APPROVED DRAWINGS HAVE BEEN RED LINED INDICATING A CHANGE TO MEET THE OBC. PLEASE REVIEW ALL PAGES TO ENSURE YOU ARE PROPERLY INFORMED OF CHANGES.

**TOWNSHIP OF NORTH DUMFRIES
BUILDING DEPARTMENT**

These Plans have been examined for Compliance with the Ontario Building Code requirements. A Building Permit has been Issued, subject to any changes noted, under the condition that the building will be constructed in accordance with the code.

client: Tice River Homes
 location: Ayr
 project: Legacy
 marketing name:

FRONT ELEVATION ELEV 'A' (LEFT)

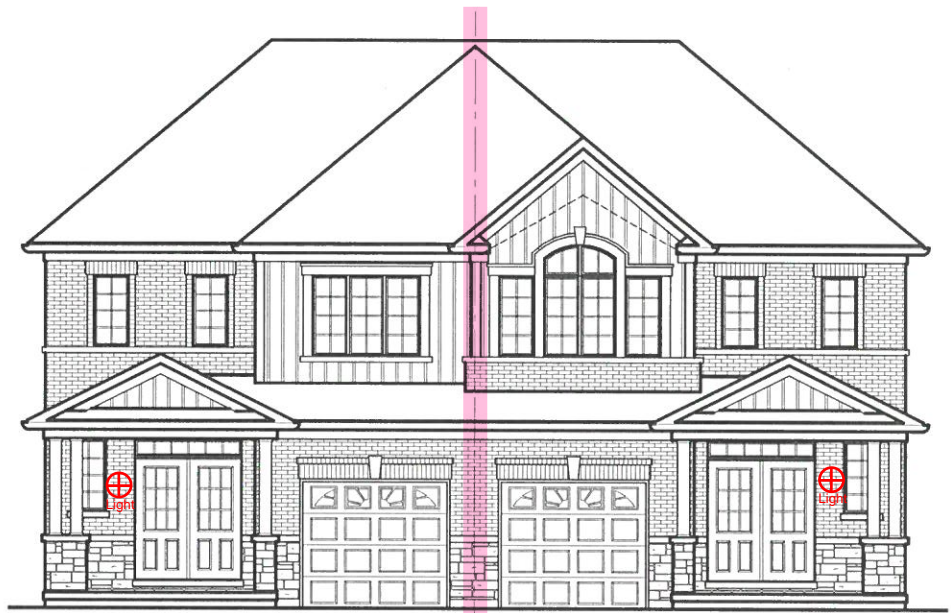
TIGHTLY FIT ELECTRICAL BOXES WHERE BOXES ARE LOCATED ON BOTH SIDES OF WALL PROVIDING A F.R.R., OFFSET BOXES AT LEAST ONE STD SPACE TO MAINTAIN INTEGRITY OF FIRE SEPARATION.

CALL FOR INSPECTION OF EXCAVATION CRIBBING BEFORE POURING ANY CONCRETE

ANY MODIFICATIONS TO GRADING SHALL NOT ADVERSELY AFFECT NEIGHBORING PROPERTIES.

FINAL GRADING CERTIFICATE REQUIRED BEFORE FINAL INSPECTION SIGN-OFF

**BASMENT FLOOR PLAN
ELEV. 'A' & 'B' (LEFT)**

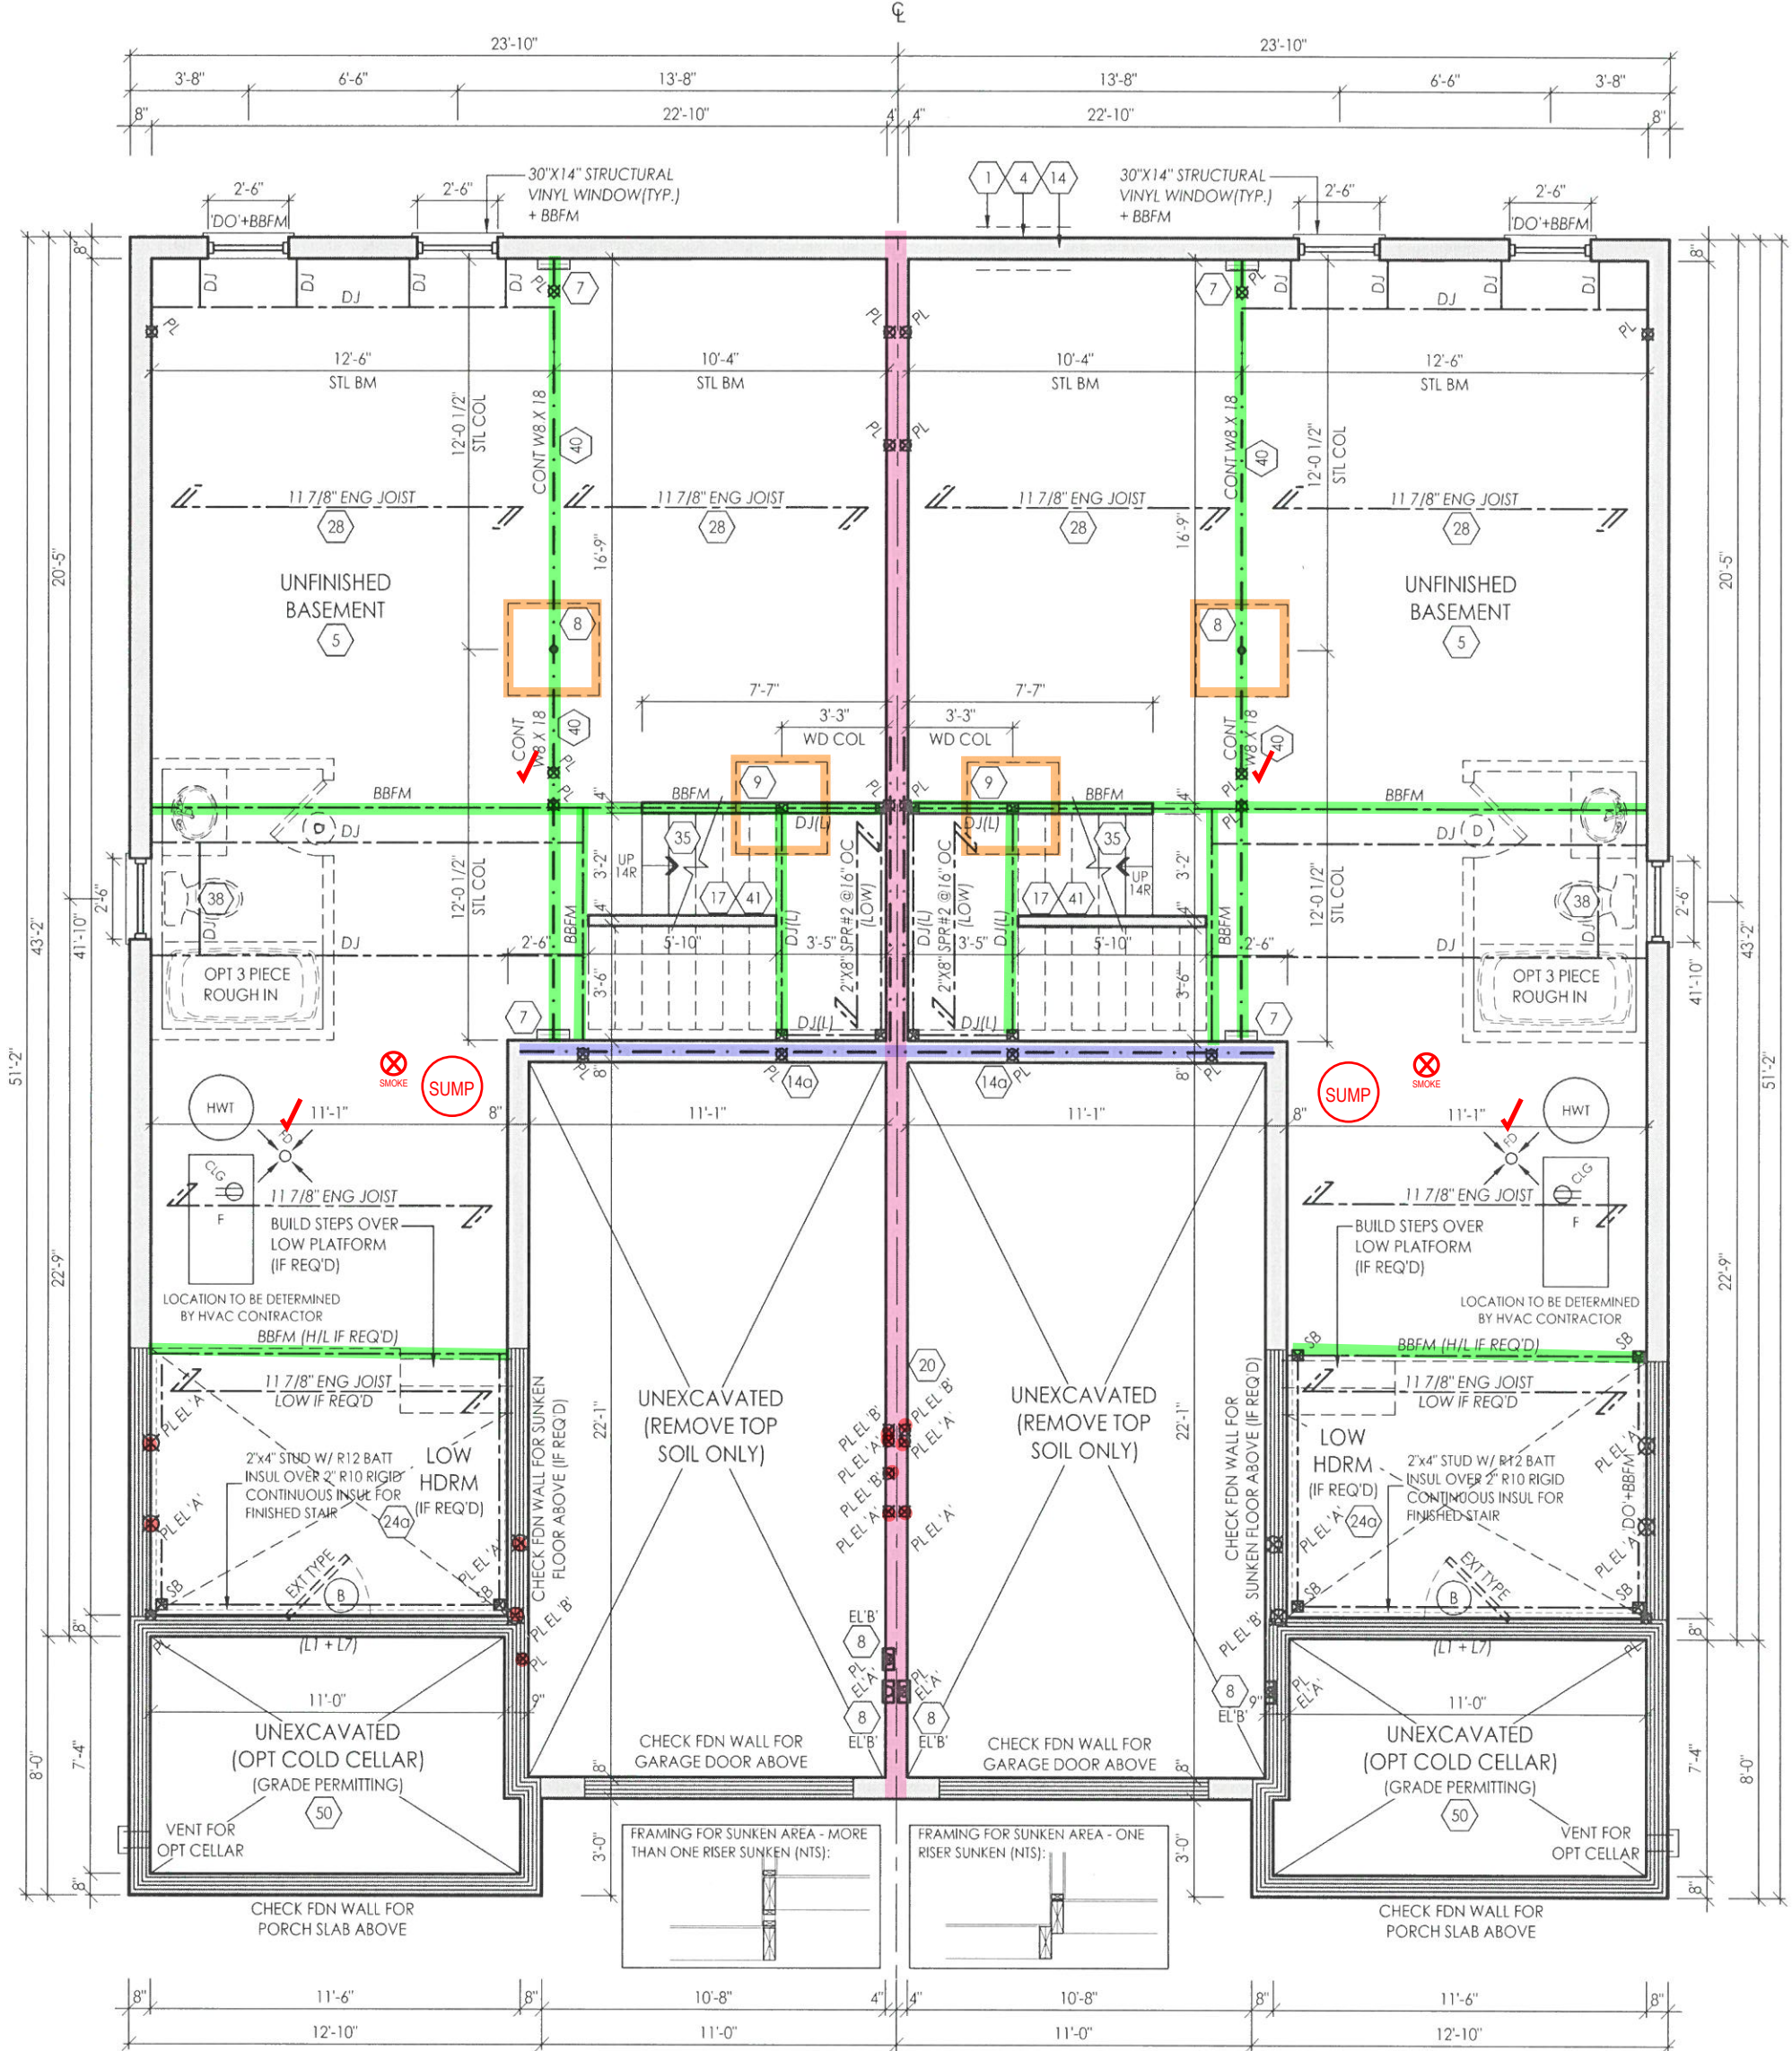
A SEPARATE BUILDING PERMIT WILL BE REQUIRED TO FINISH THE BASEMENT.

INSULATION IS REQ'D TO BE CONTINUOUS.

SECOND FLOOR PLAN ELEV. 'B' (LEFT)

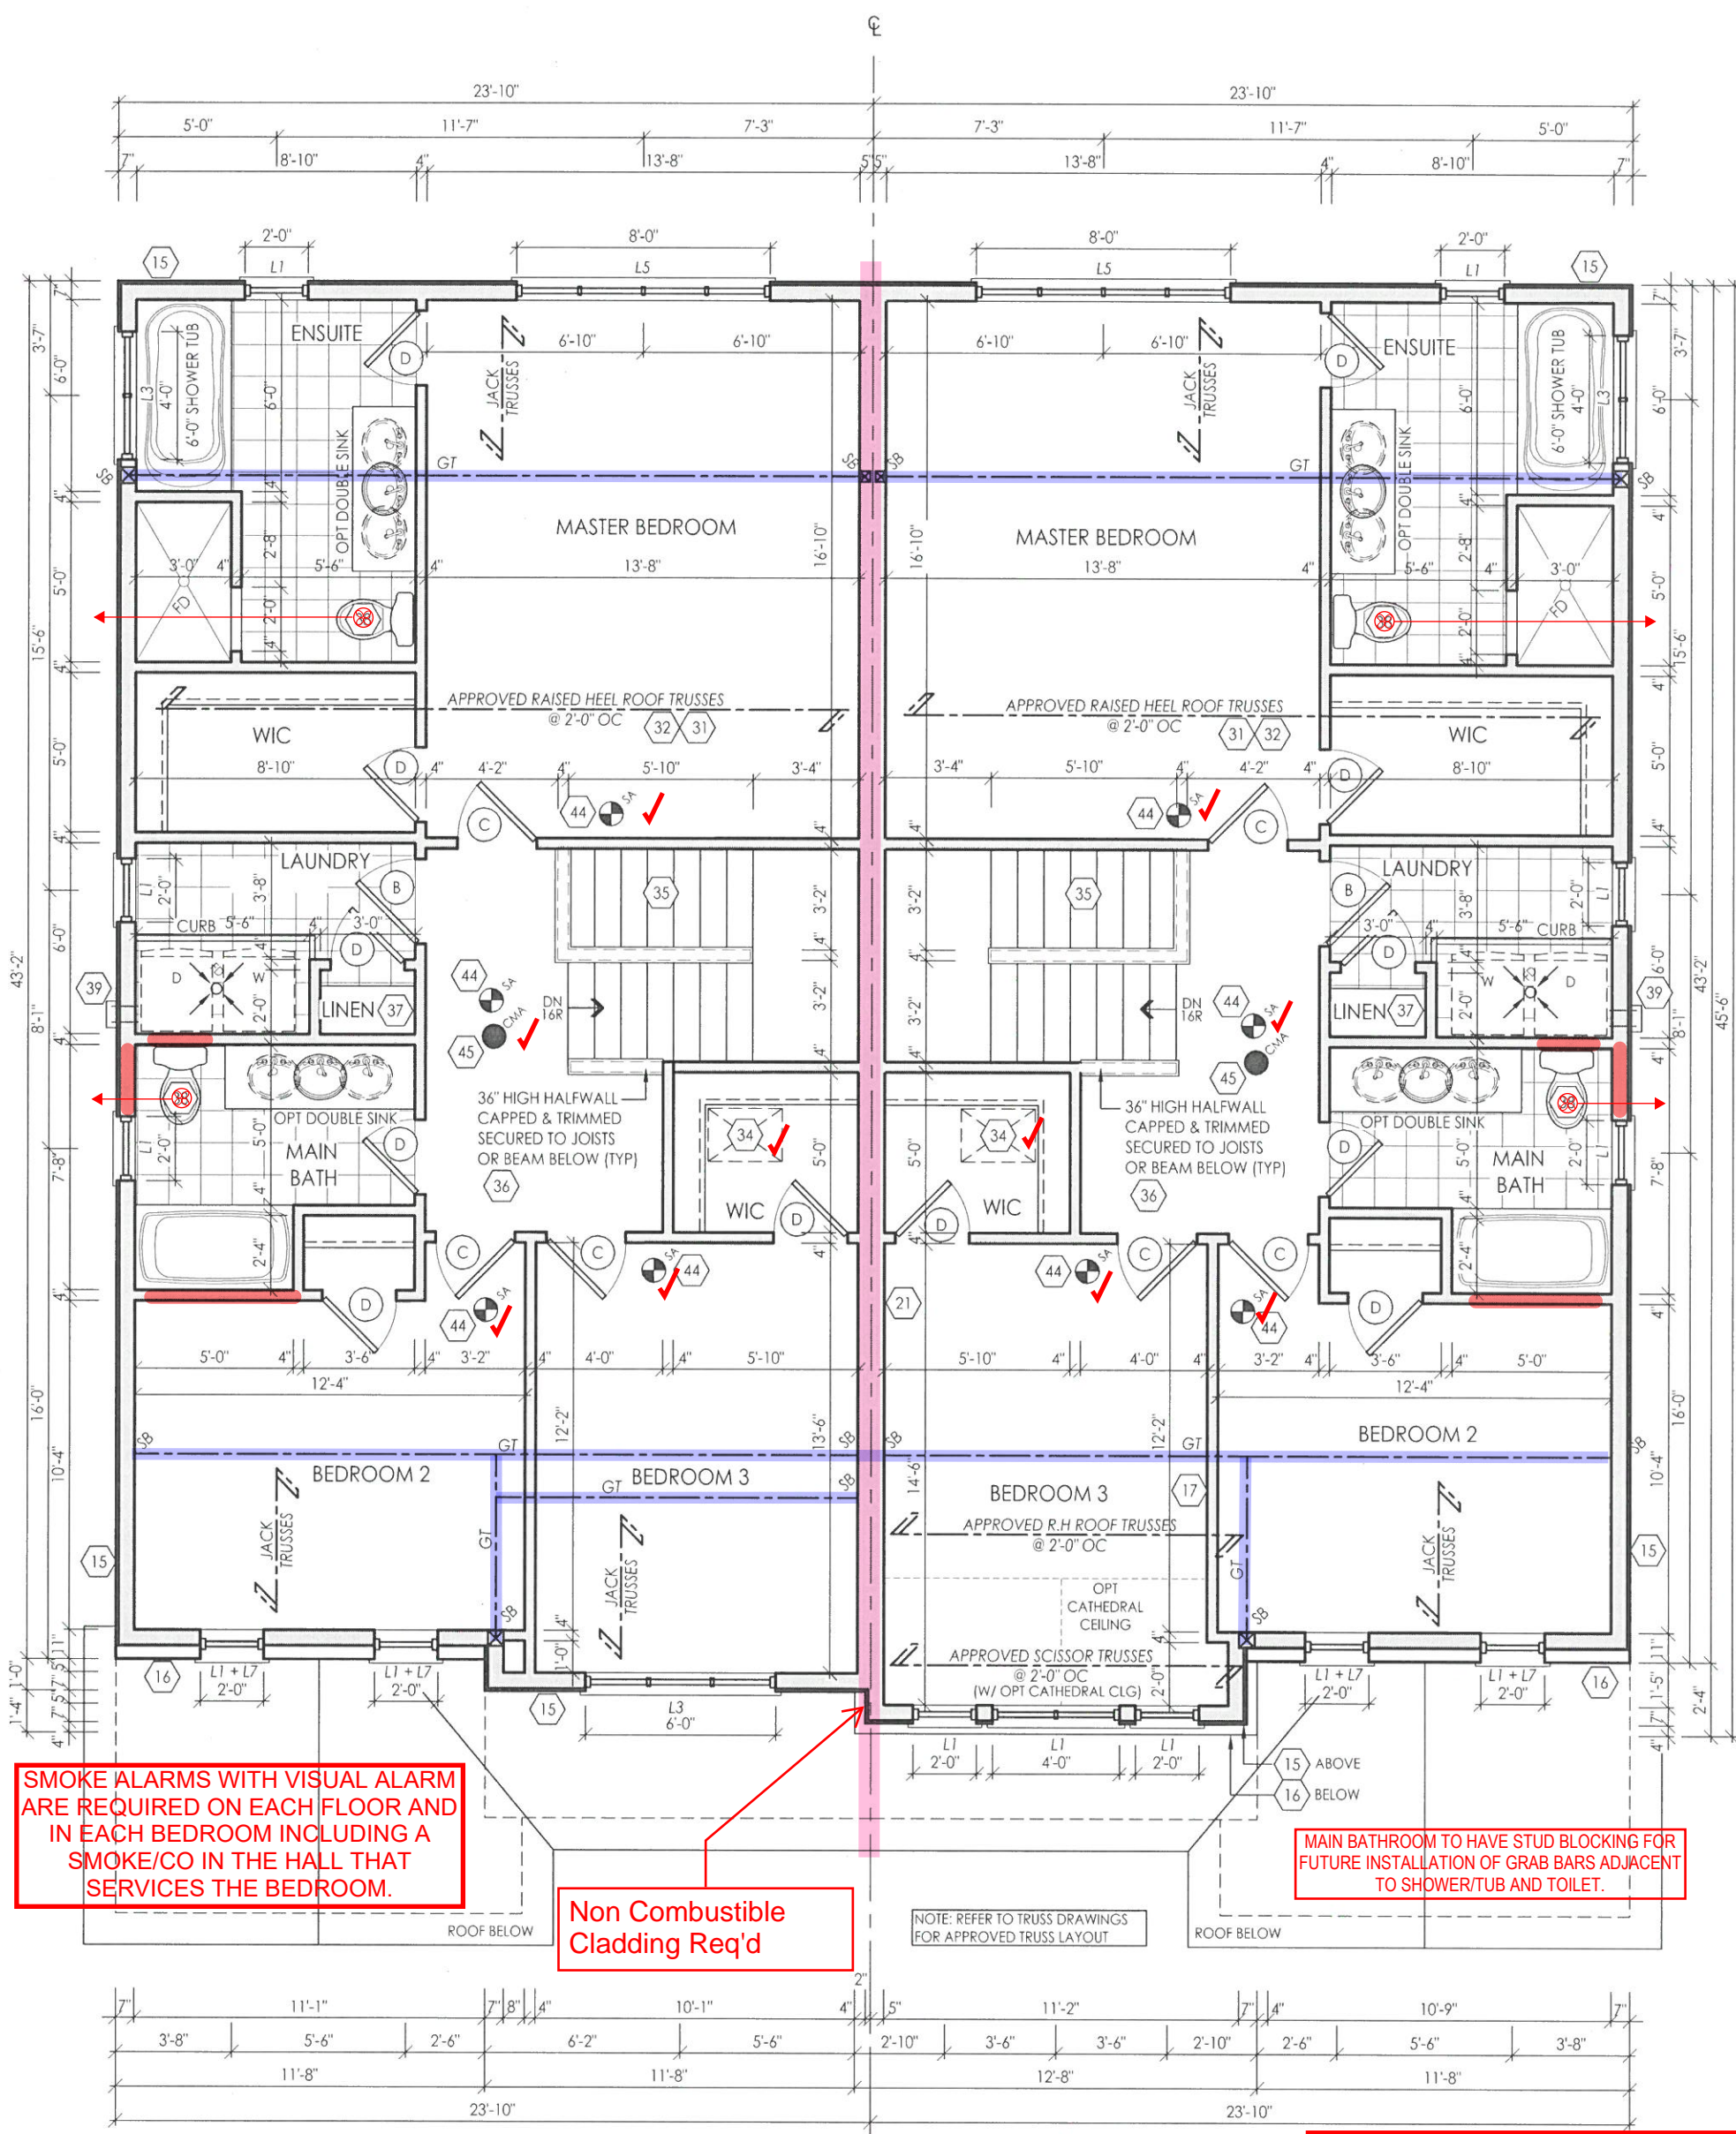
SMOKE ALARMS WITH VISUAL ALARM ARE REQUIRED ON EACH FLOOR AND IN EACH BEDROOM INCLUDING A SMOKE/CO IN THE HALL THAT SERVICES THE BEDROOM.

Non Combustible Cladding Req'd

MAIN BATHROOM TO HAVE STUD BLOCKING FOR FUTURE INSTALLATION OF GRAB BARS ADJACENT TO SHOWER/TUB AND TOILET.

AT LEAST 1 WINDOW SHALL PROVIDE AN UNOBSTRUCTED AREA OF 22" X 39" W/ A SILL HEIGHT MAX. 3'-3" ABOVE FINISHED FLOOR & 23'-0" ABOVE GRADE
